From: WELLS Russell (AREVA) [Russell.Wells@areva.com]
Sent: Wednesday, April 27, 2011 8:34 AM
To: Tesfaye, Getachew
Cc: HAMMOND Philip (AREVA); HARRINGTON James (AREVA); WILLIAMSON Rick (AREVA); BENNETT Kathy (AREVA); DELANO Karen (AREVA); HALLINGER Pat (EXTERNAL AREVA); ROMINE Judy (AREVA); RYAN Tom (AREVA); WILLIFORD Dennis (AREVA)
Subject: Draft Response to U.S. EPR Design Certification Application RAI No. 422, FSARCh. 3, Questions 3.9.2-82, 98, and 145
Attachments: RAI 422 Questions 03.09.02-82, -98, and -145 Response US EPR DC - DRAFT.pdf

To support the final response date of June 15, 2011, attached is a draft response to RAI 422 questions 3.9.2-82, 98, and 145. Let me know if the staff has questions or if this can be sent as a final response.

From: WELLS Russell (RS/NB)
Sent: Wednesday, April 20, 2011 6:32 AM
To: 'Tesfaye, Getachew'
Cc: HAMMOND Philip (RS/PT); BENNETT Kathy (RS/NB); DELANO Karen (RS/NB); ROMINE Judy (RS/NB); RYAN Tom (RS/NB)
Subject: Response to U.S. EPR Design Certification Application RAI No. 422, FSARCh. 3, Supplement 17

Figure 03.09.02-98-1—Permanent Sensor Locations – Main Steam and Main Feed Water Overview

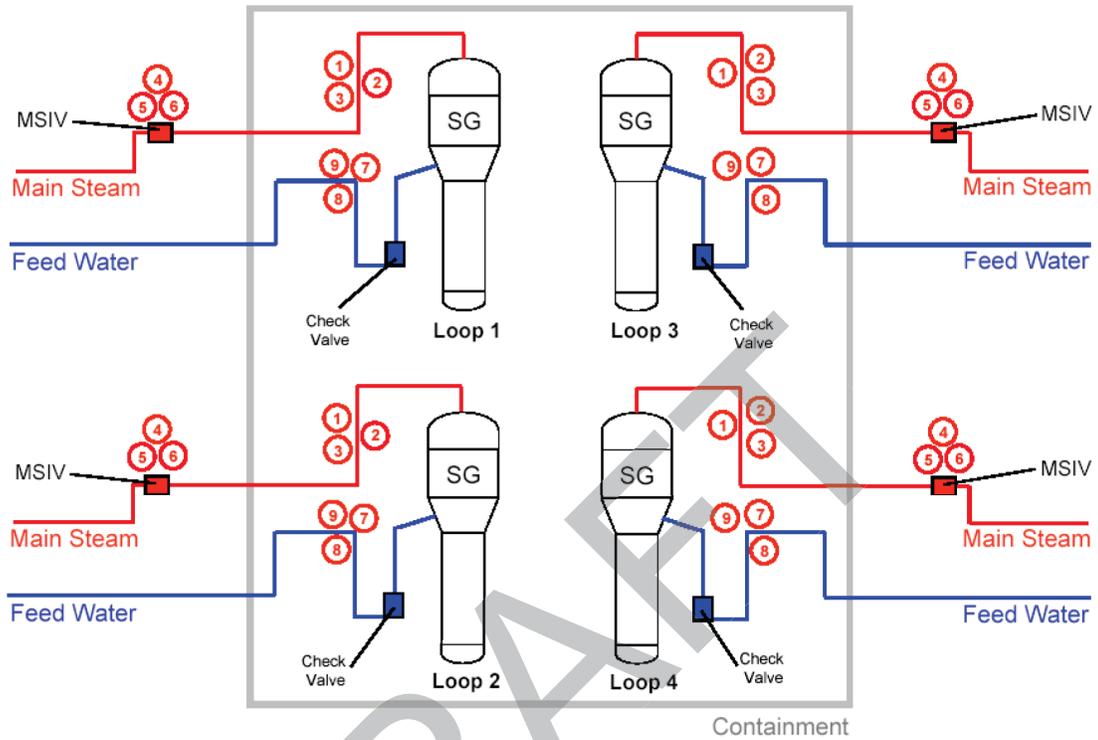
The staff reviewed the applicant's description of the instrumentation for the piping systems external to the RSG but have a contact with RSG (e.g. the main steam, main feedwater and the reactor cooling system) as outlined in Appendix A.3 and shown in Figures A-2 and A-3. The applicant is requested to provide the details of the instrumentation, including types, locations, specifications/ accuracy and ability to detect acoustic resonances that affect the RSG.

The MSL and MFWL will be instrumented with accelerometers in a triaxial configuration on each of the four loops as part of the permanent vibration monitoring system (VMS) (see Figure 03.09.02-98-1). During initial startup, additional temporary sensors will be located on a single loop (see Figure 03.09.02-98-2 and Figure 03.09.02-98-3), similar to the temporary instrumentation on a single loop for the reactor coolant system (RCS). The same loop will be instrumented in both cases. The results from this loop will be compared to analysis to determine acceptability. The results from the permanent sensors of the four loops are compared to determine the acceptability of the three loops that do not have the additional temporary sensors.

Figure 3.9.2-98-1 provides an overview of MSL and MFWL permanent sensor locations. Figure 3.9.2-98-2 shows MFWL permanent and temporary sensor positions. Figure 3.9.2-98-3 shows MSL permanent and temporary sensor positions.
